Wisconsin Department of Transportation

Proposal #39: 8610-02-74, WISC 2025175
C Chippewa Falls, Bay Street
High Street to Bridge Street
STH 124
Chippewa County

8610-08-73, WISC 2025176
Chippewa Falls – Bloomer
Elm Street to CTH S
STH 124
Chippewa County

This is Addendum No. 02, which provides for the following:

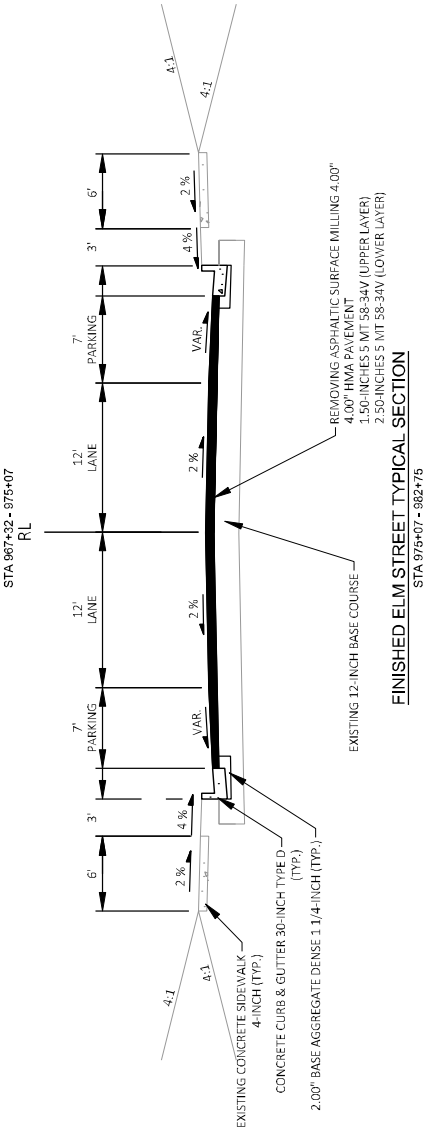
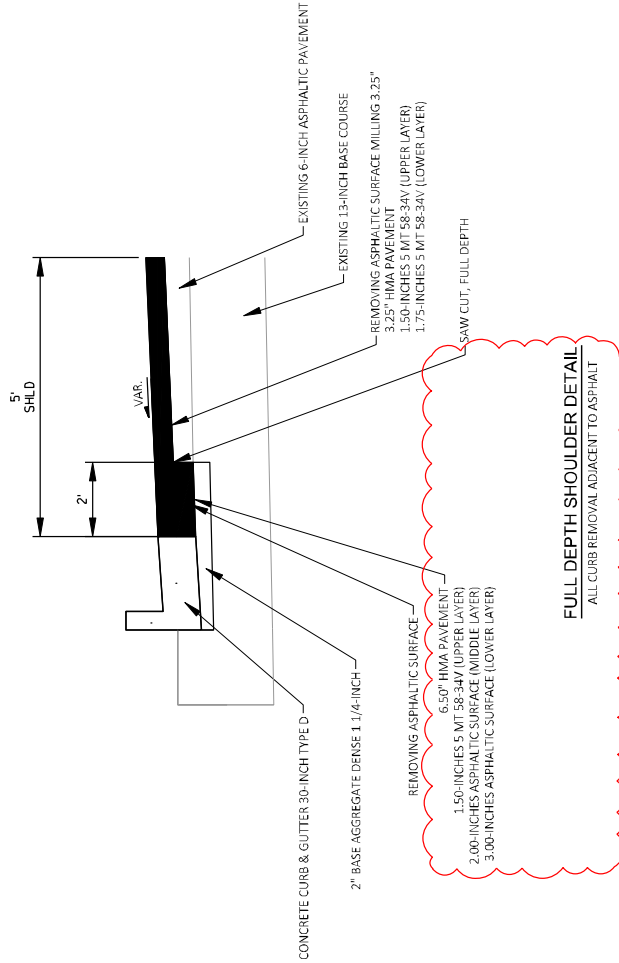
Revised Plan Sheets	
Plan Sheet	Plan Sheet Title (brief description of changes to sheet)
11	Typical Section - Updated callout to use Asphaltic Surface near curbs
24	Construction Detail - Updated callout to use Asphaltic Surface near curbs
169	Miscellaneous Quantity - Updated Removing Asphaltic Surface quantity
170	Miscellaneous Quantity - Updated Removing Asphaltic Surface quantity
175	Miscellaneous Quantity - Updated HMA Pavement and Asphaltic Surface quantities
176	Miscellaneous Quantity - Updated HMA Pavement and Asphaltic Surface quantities
178	PWL Mixture Use Table - Updated Bid Item and Underlying Surface columns
181	Miscellaneous Quantity - Updated Construction Staking Curb Ramp quantity
182	Miscellaneous Quantity - Updated Construction Staking Curb Ramp quantity
183	Miscellaneous Quantity – Added Cover Plates Temporary Bid Item
184	Miscellaneous Quantity – Added Cover Plates Temporary Bid Item
